OU2 ADDITIONAL WORK (LANDFILL)

OEPA/DOE-FMPC

January 29, 1991

RE: OU2 ADDITIONAL WORK
(LANDFILL)

FIGURE 1-3. SANITARY LANDFILL

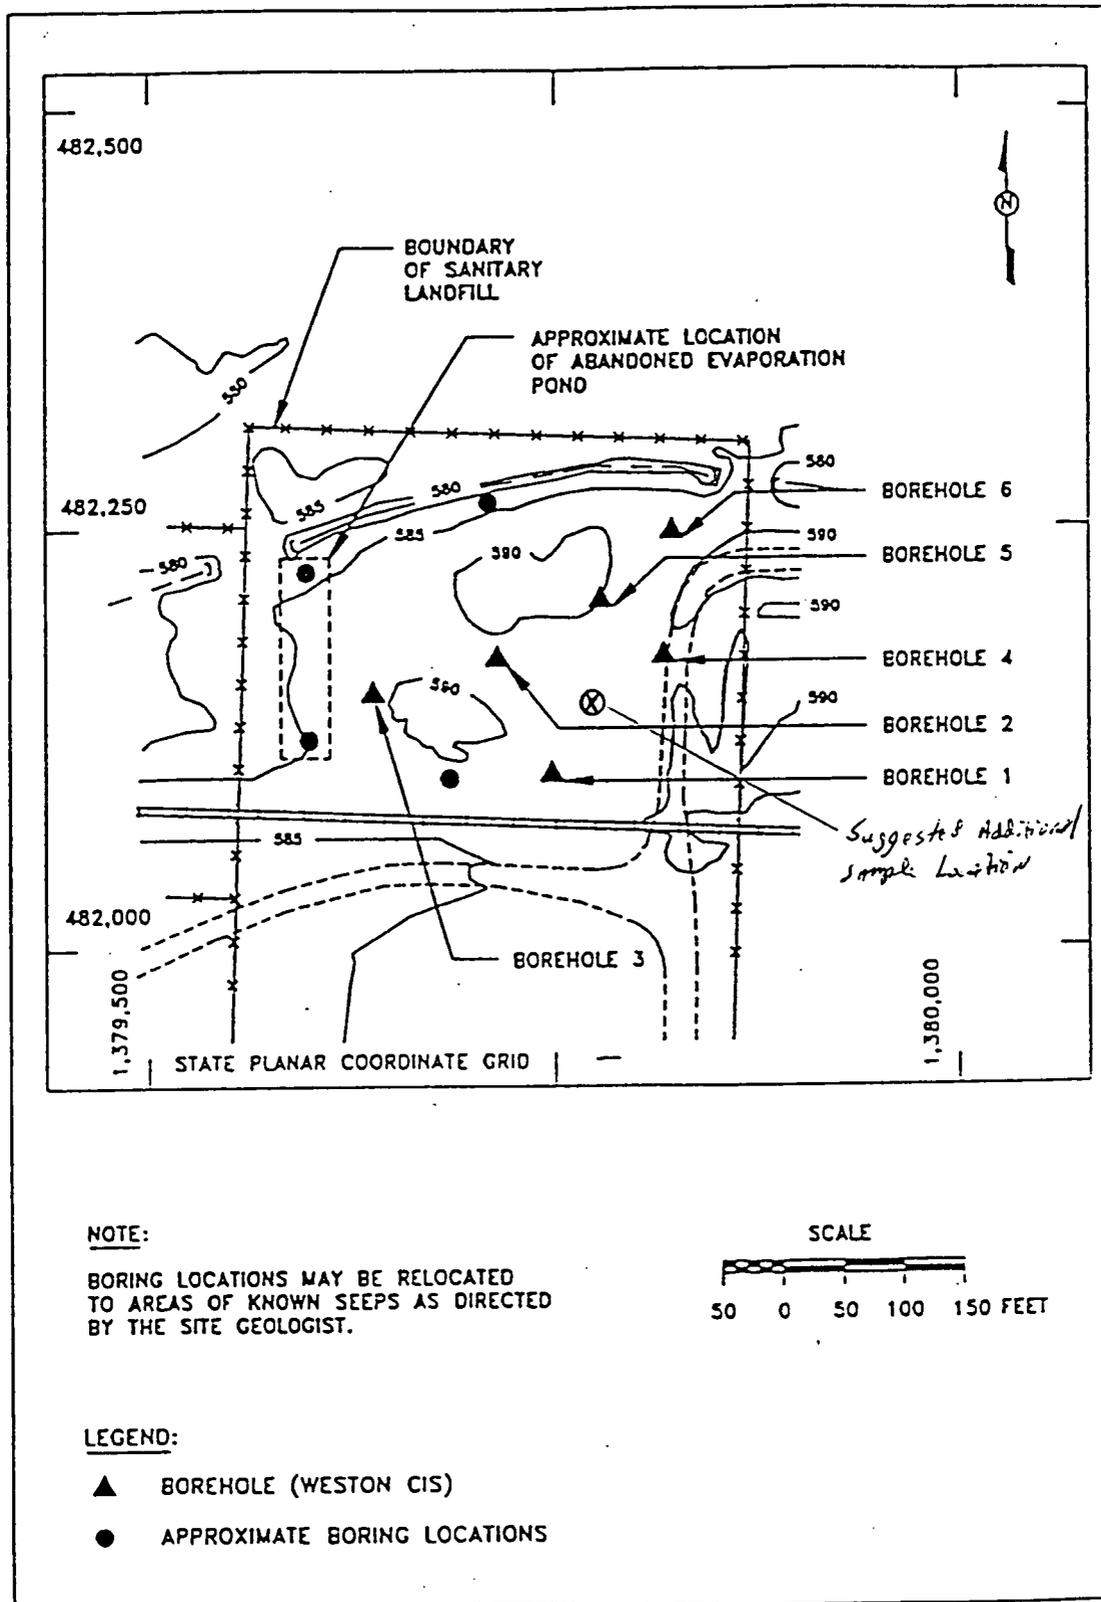
In a letter dated November 21, 1990, Ohio EPA approved the Work Plan for additional work in OU2 with the exception of the sanitary landfill. DOE responded on January 16, 1991, with additional justification for not needing another boring in the original disposal area. Nevertheless, it is still the opinion of Ohio EPA that an additional sample should be collected in the middle of the area encircled by Weston CIS samples 1, 2, 4, & 5. Ohio EPA maintains that most of the Weston CIS samples are located on the periphery of the original disposal area. The proposed location is in the center of what is believed to be the original disposal area, as shown in Figure 1-3 of the Revised OU2 ISA (1-91). The sample would also allow TCLP analysis in an area in which it has not been conducted. The sample proposed by Ohio EPA will allow for a more complete characterization of the original disposal area. The approximate location of the sample suggested by Ohio EPA is marked on the attached copies of the Figure 1 from the OU2 Additional Sampling Plan and Figure 1-3 of the Revised Initial Screening of Alternatives document.
